December 29, 2025

CONTRACT NO. 1797

OHIO RIVER TUNNEL

ADDENDUM No. 11

- Revised ORT-ST-200 (Sheet 117 of 770)
- Revised ORT-ST-300 (Sheet 130 of 770)
- Revised ORT-ST-400 (Sheet 141 of 770)
- Revised ORT-ST-600 (Sheet 159 of 770)
- Revised ORT-ST-700 (Sheet 169 of 770)
- Revised ORT-ST-800 (Sheet 179 of 770)

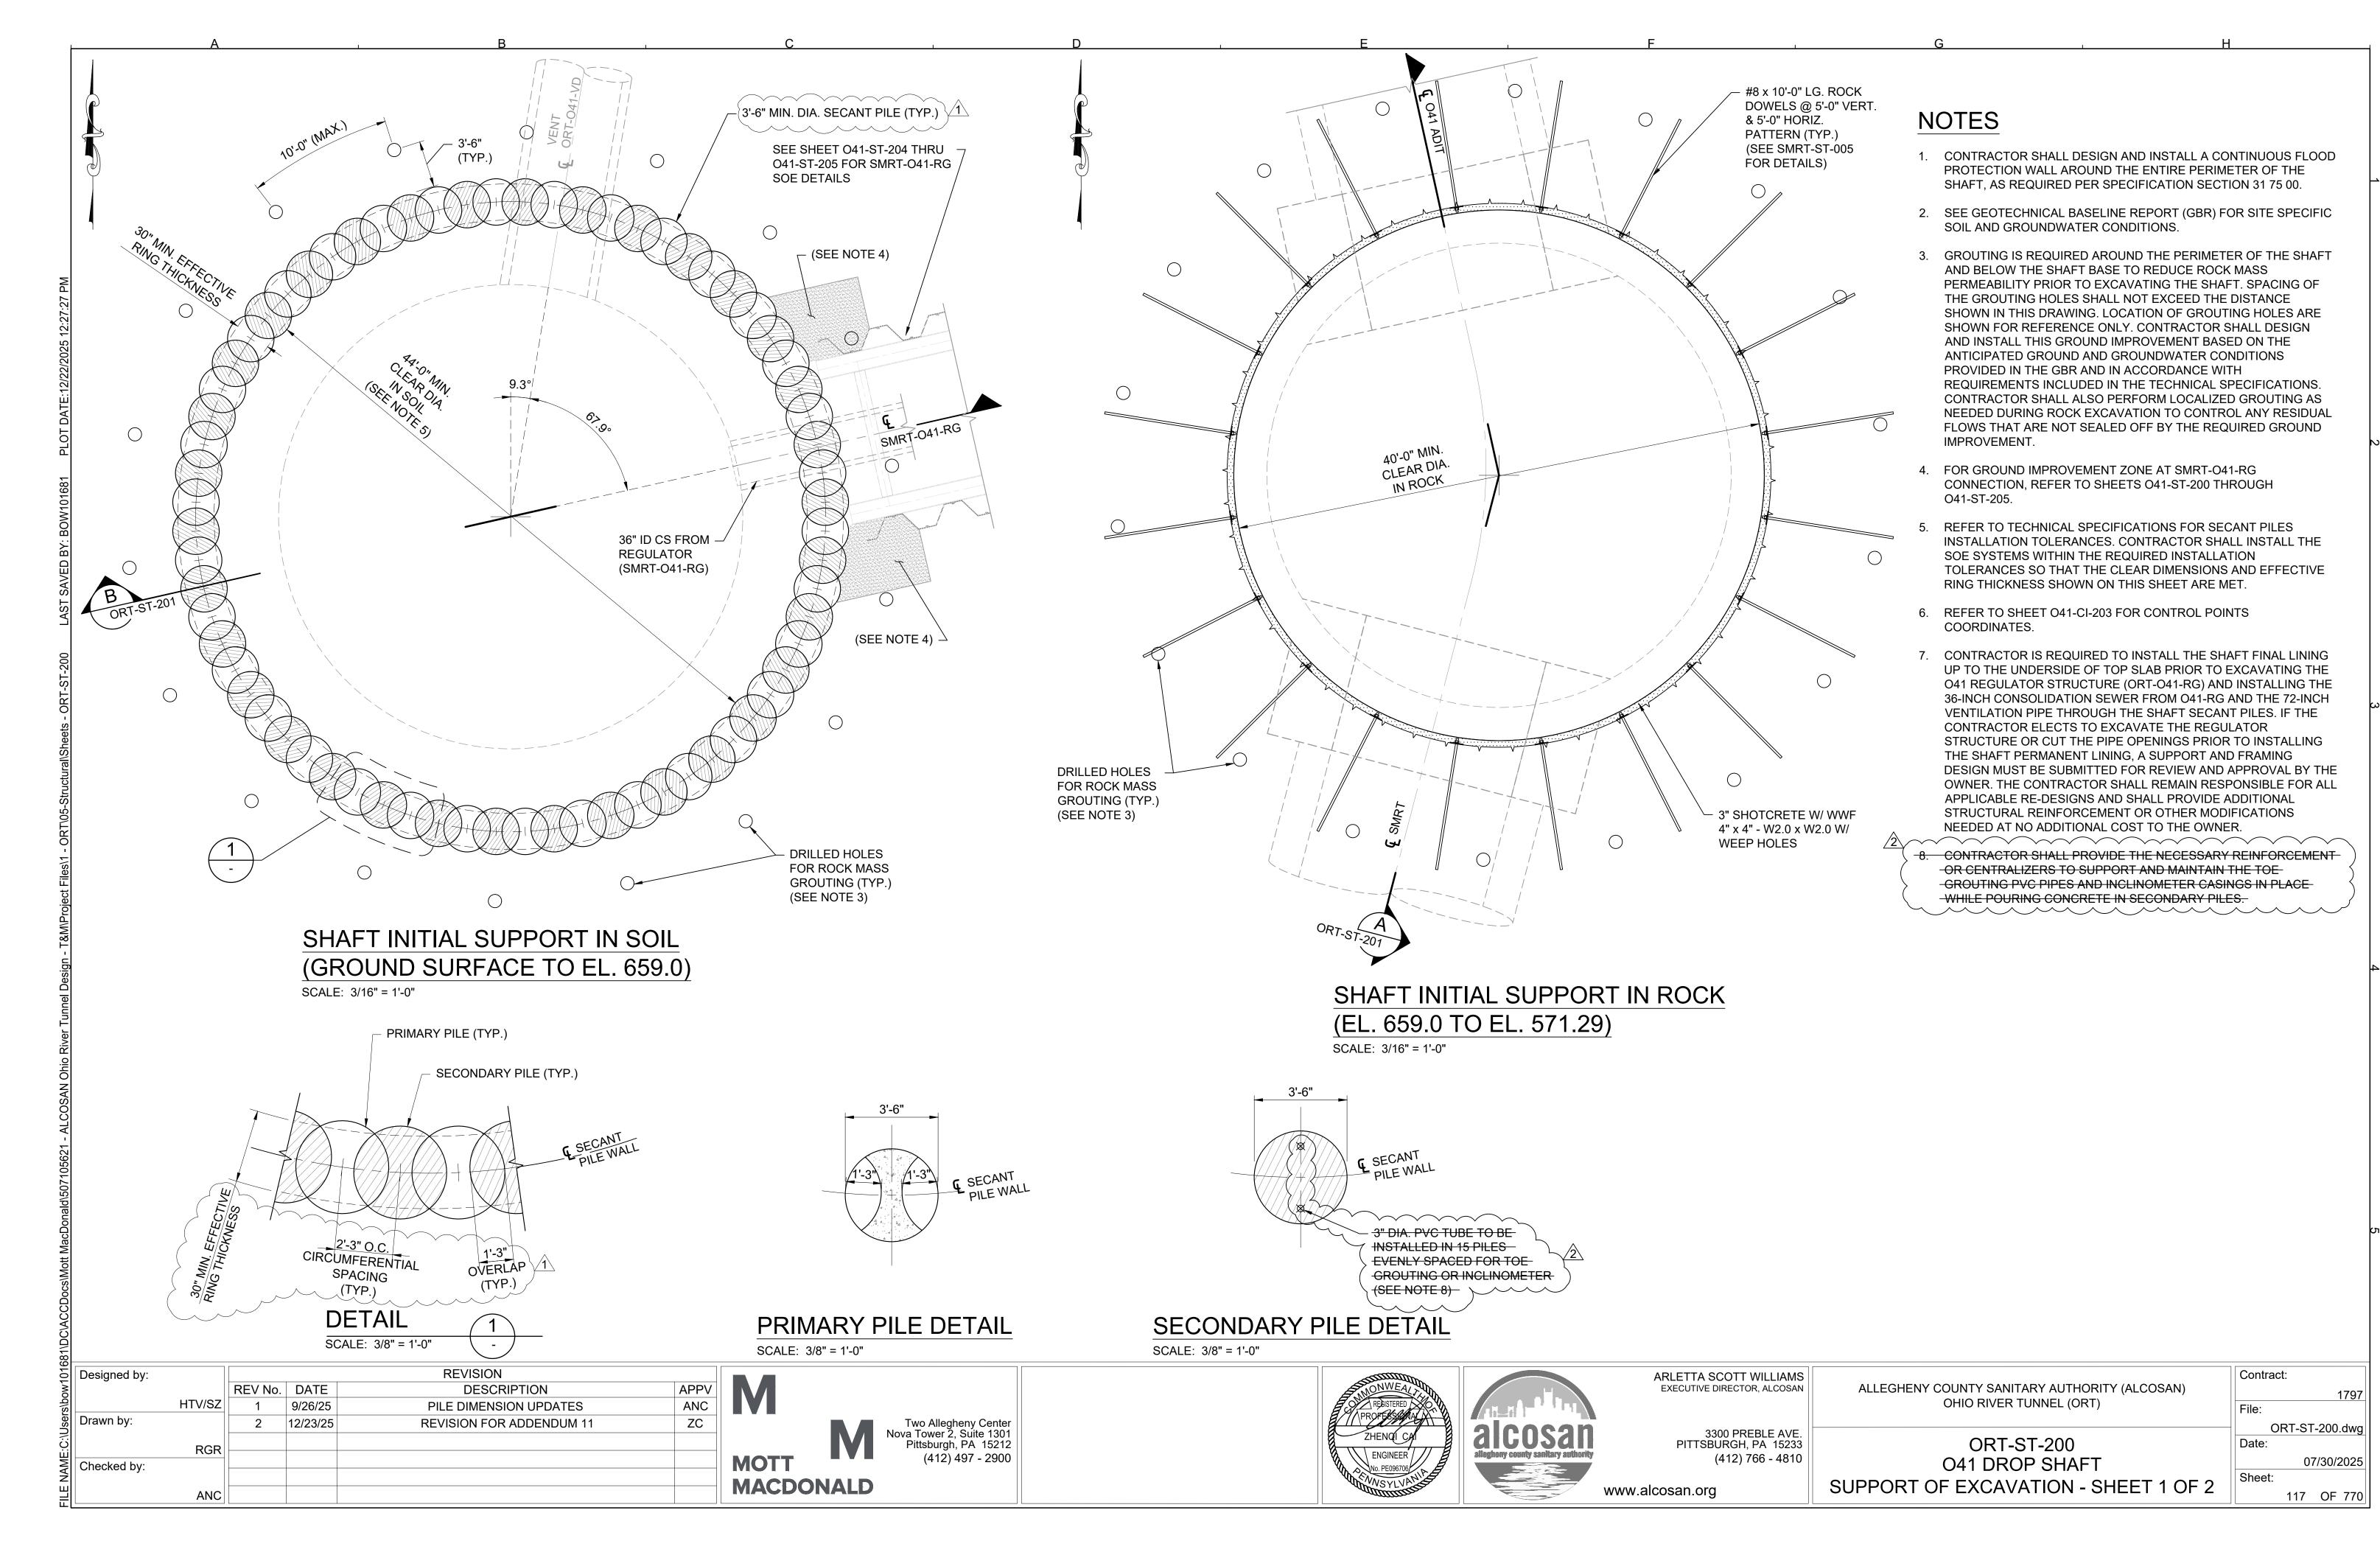
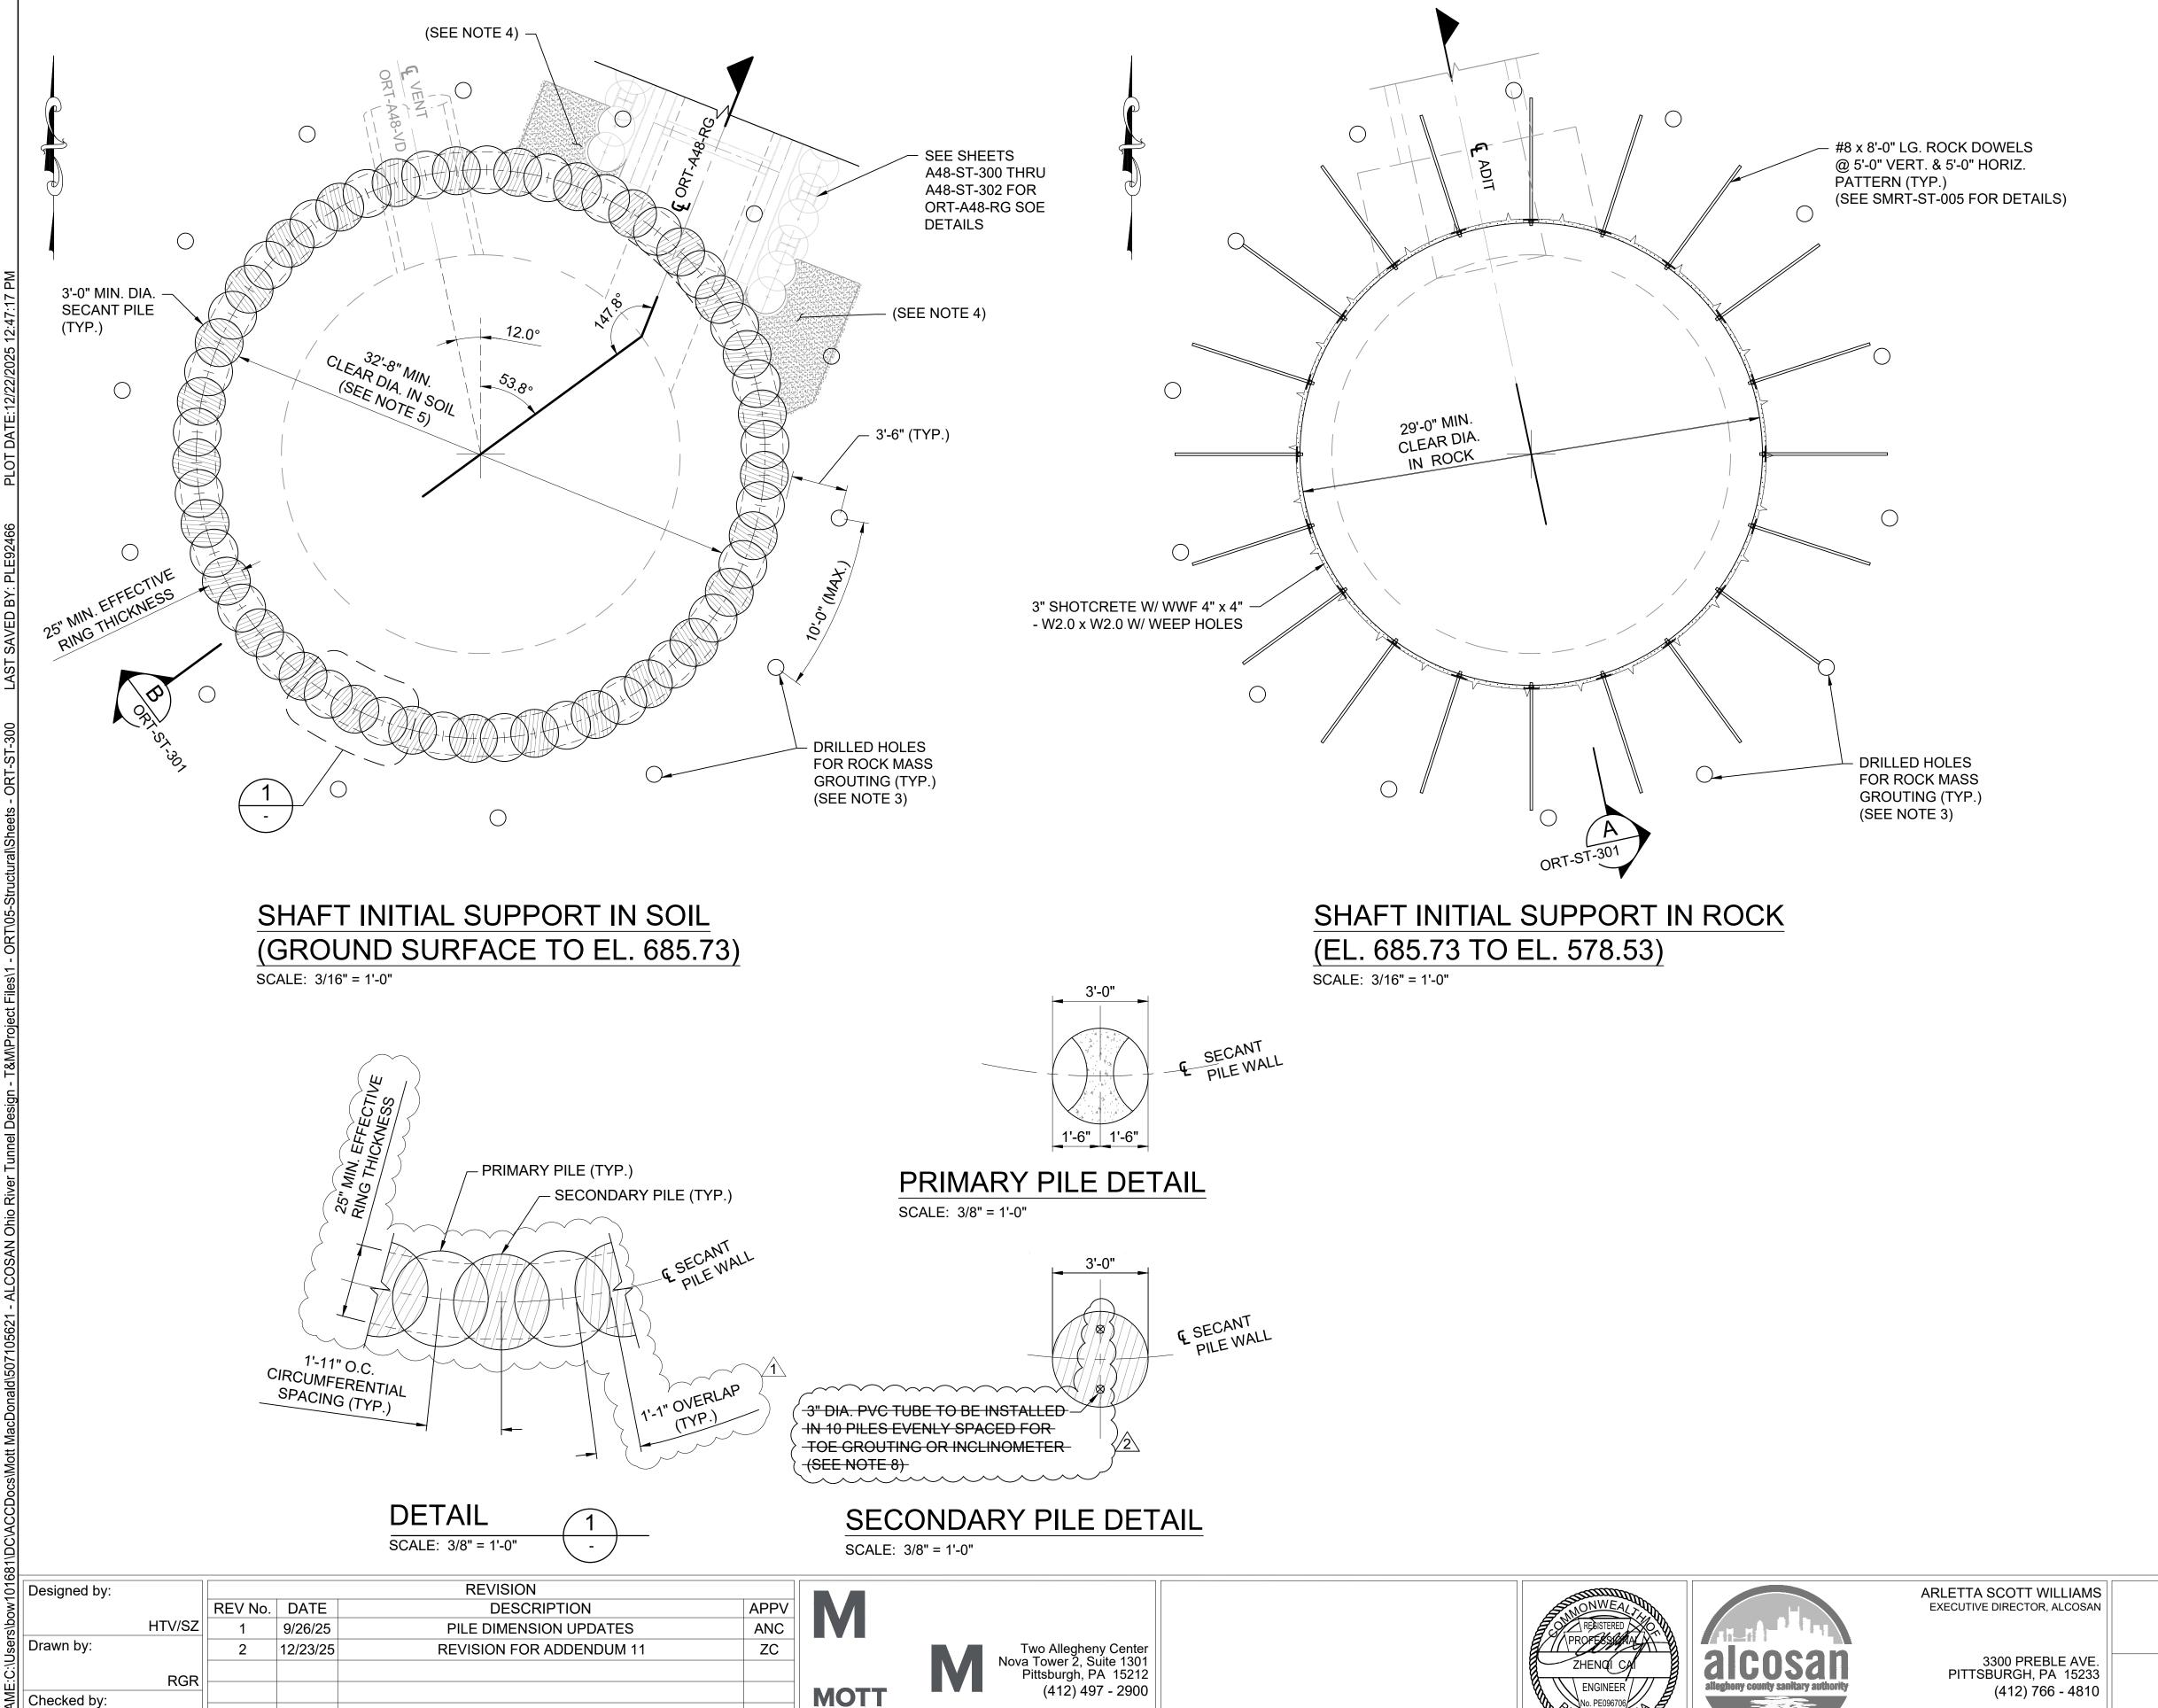
- Q38 See the following Drawings:
 - Drawing ORT-ST-200, Note #8, (O41 Drop Shaft)
 - Drawing ORT-ST-300, Note #8, (A48 Drop Shaft)
 - Drawing ORT-ST-400, Note #8, (A58 Drop Shaft)
 - Drawing ORT-ST-600, Note #8, (O14 Drop Shaft)
 - Drawing ORT-ST-700, Note #8, (O07 Drop Shaft)
 - Drawing ORT-ST-800, Note #8, (O06A Drop Shaft)

These notes state "CONTRACTOR SHALL PROVIDE THE NECESSARY REINFORCEMENT OR CENTRALIZERS TO SUPPORT AND MAINTAIN THE TOE GROUTING PVC PIPES AND INCLINOMETER CASINGS IN PLACE WHILE POURING CONCRETE IN SECONDARY PILES."

Question #2 – The note in the Secondary Pile Detail points to one pipe. However, two pipes are shown in the detail. How many 3" PVC tubes are to be included in the secondary piles covered by this note?

- Answer to Questions #1 and #2: Note 8 on these drawings have been removed. As stated in Section 31 57 00 (Secant Pile Wall) Part 1.6.D.8, the Contractor shall submit "Procedures and mix designs for grouting of the toe of the secant piles to seal the secant pile wall/ground interface, where applicable." Refer to Addendum 009, Q15/A15 for additional information. See Section B Item 16 and Attachment I for Changes to Contract Documents.
